## Product change information

PCN no.	AAA160043	Date	22.06.2016
Article	PT 1.5/..-5.0-H + V

#### Optimization of the solder pin guide

Previous production status	New production status

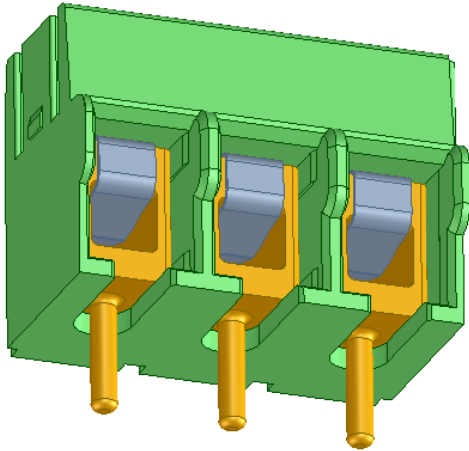
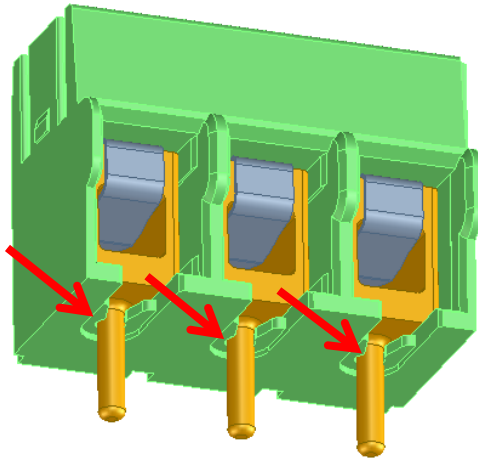
In the course of our continuous product improvement, the solder pin guide of the PT 1.5-5.0 product series will be optimized. This adjustment applies to the horizontal as well as the vertical product versions. Further technical features remain unaffected by this change.

- Constriction of the solder pin guide

- Optimized solder pin guide
- Compatibility remains unaffected
- Old and new version can be applied in parallel
